Irish Standard  
I.S. 327-3:1987

# Domestic Installations Using Liquefied Petroleum Gases

## AMENDMENT

NO. 2 : 1988

Figure 5. Position of balanced flue terminal.

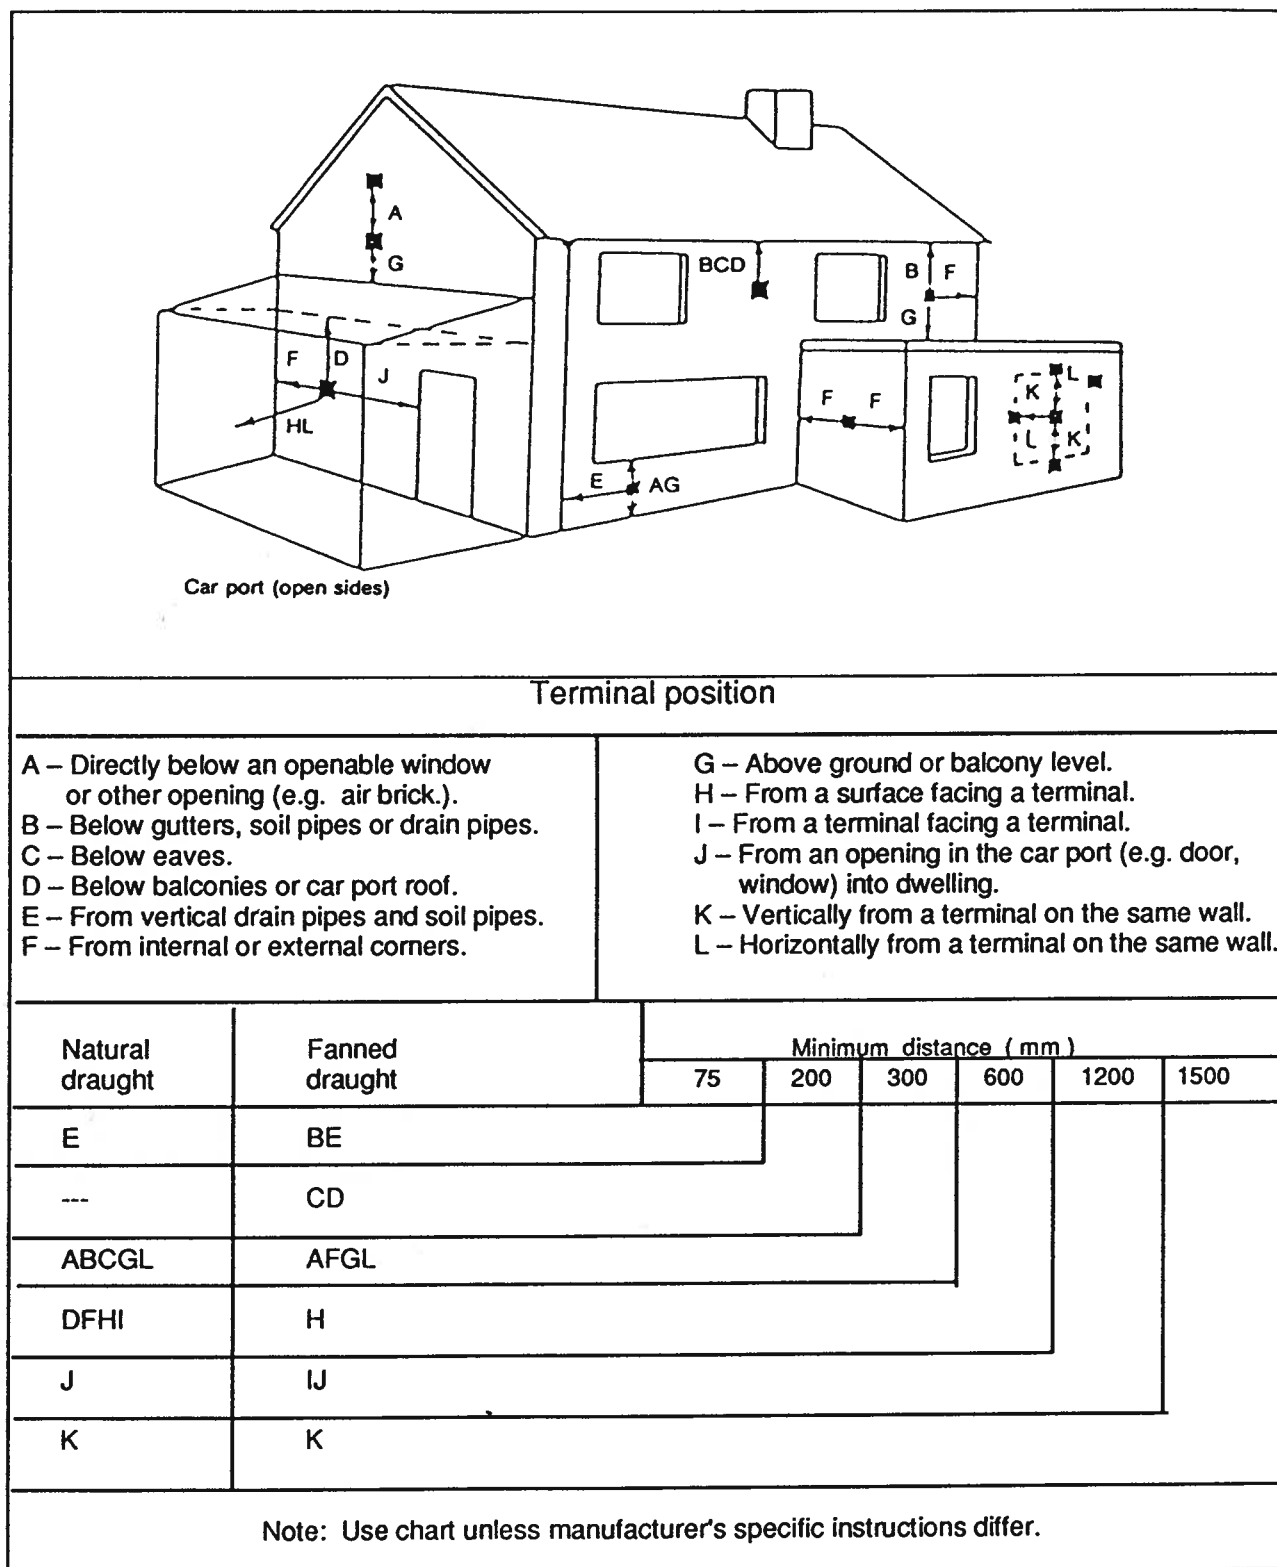
PART 1. Page 27. Delete the existing Figure 11 and substitute Figure 5 as follows:
